CITY OF VANCOUVER
POLICY REPORT
DEVELOPMENT AND BUILDING

Report Date: March 27, 2007
Author: Joanne Baxter
Phone No.: 604.871.6656
RTS No.: 06163
VanRIMS No.: 11-3600-01
Meeting Date: April 17, 2007

SUBJECT: CD-1 Rezoning - 5475 Dunbar Street, 3625 and 3641 West 39th Avenue

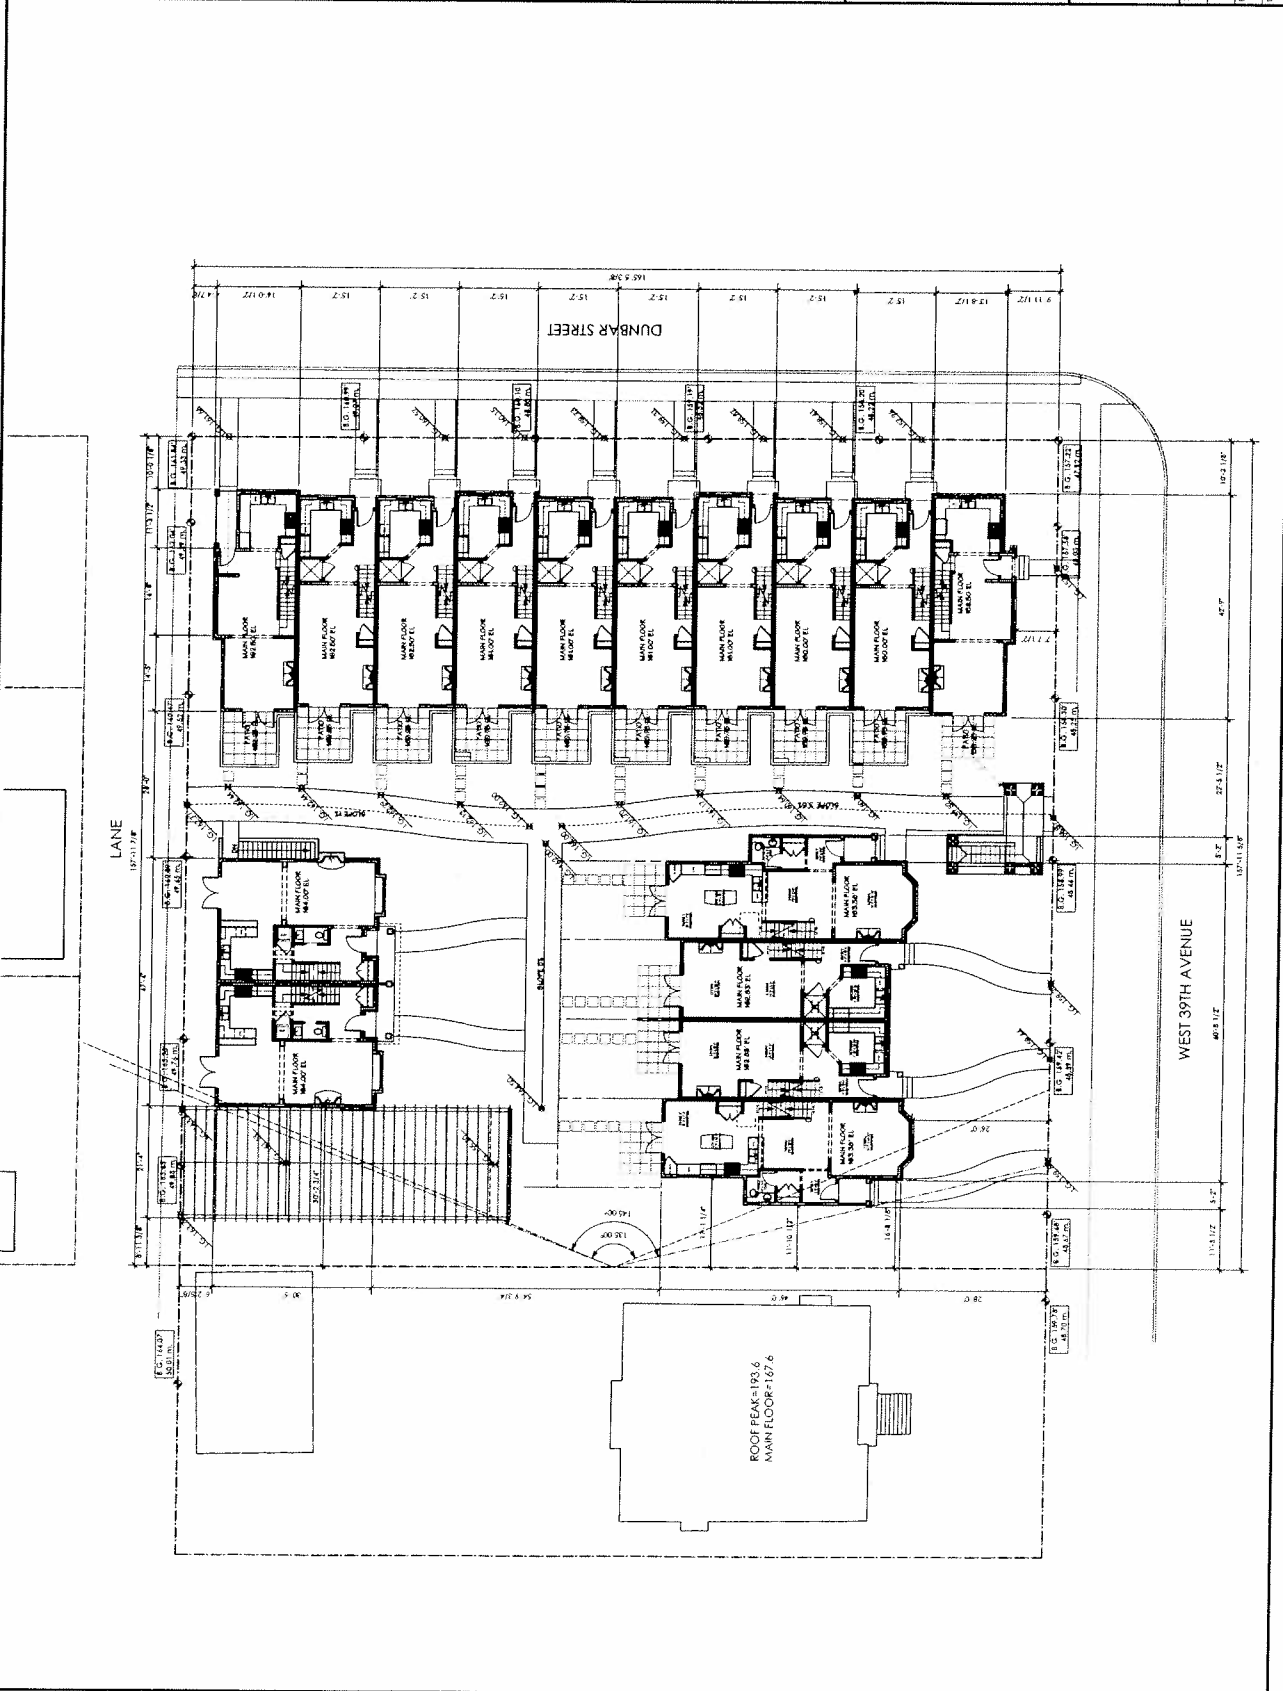
- (i) design development to enclose and combine exit stairs with the building structure and to relocate stair exit from the front property line and main pedestrian entry along West 39th Avenue;

(Note to Applicant: Open stair wells to the underground parking are not supported. Consider a second means of egress via the parking ramp, possibly eliminating one of the two exit stairs).
- (ii) design development to the south yard setback at West 39th Avenue of the southeast dwelling unit, increasing the yard setback by a minimum of one foot;

(Note to Applicant: A more compatible yard setback along West 39th Avenue between the proposed four-plex and the rowhouses is sought).
- (iii) design development to re-align the pedestrian pathway to provide a minimum three foot clearance along the east elevation of the four-plex;

(Note to Applicant: Provide landscaping between the pathway and the four-plex).
- (iv) Design development to minimize the size and visibility of the parking ramp as seen from the neighbour;

(Note to Applicant: Provide detail sections of the ramp slope and at the property line indicating maximum permitted slope and minimum required height clearances. Parking ramp should be well integrated with the landscaping and screened at the side yard [see also condition (b)(v)].

- (v) design development to provide a detailed landscape plan, with particular regard to side yard conditions and maintaining privacy between neighbours;

(Note to Applicant: Landscaping along the west side yard should be layered and densely planted to provide screening between neighbours. Provide a strongly defined landscaped edge for the rear patios of the rowhouses immediately adjacent to the pedestrian entry and path off of West 39th Avenue).

DRAWING
Building #2
(37th Avenue)

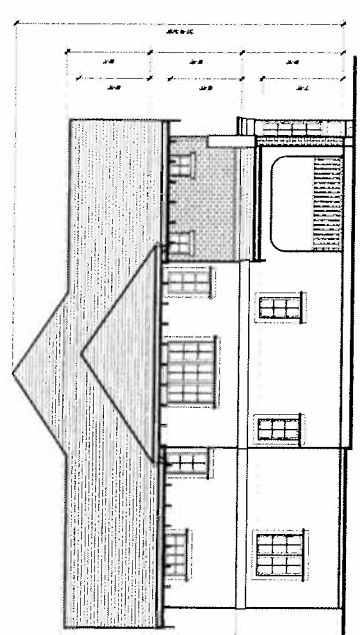
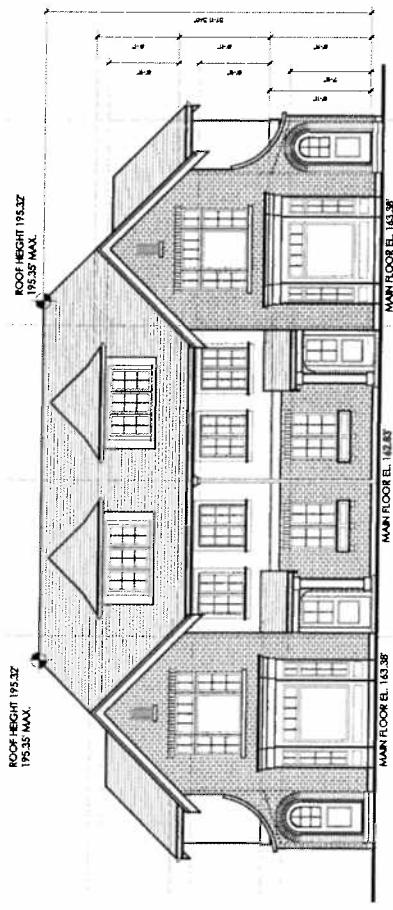
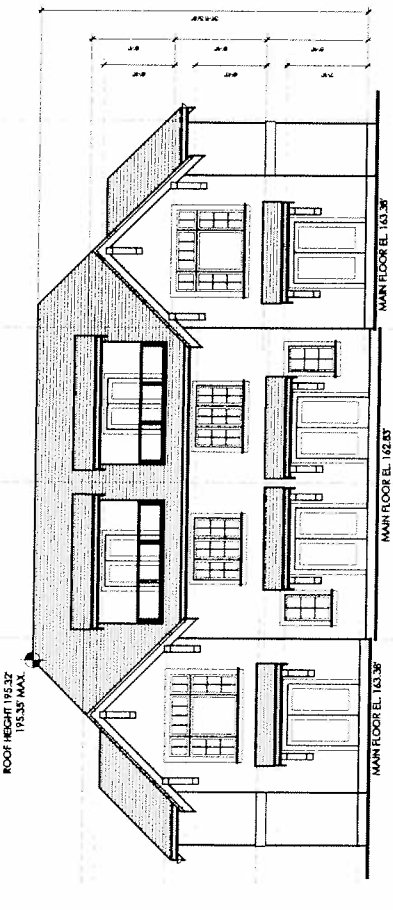
- (viii) provide clarification on the drawings, indicating the location of the windows of the adjacent building on the west side elevation of the proposed four-plex;

(Note to Applicant: Windows should not have direct overlook with neighbours).

Some Panel members noted that the fourplex is pulled back in line with the single family homes on West 39th Avenue but the side yard of the townhouses fronting Dunbar are much tighter. The fourplex could move forward slightly. The side yards of the townhouses to the lane and flanking West 39th Avenue are tight. It was felt that removing one of the townhouses might be necessary to improve this setback condition.”
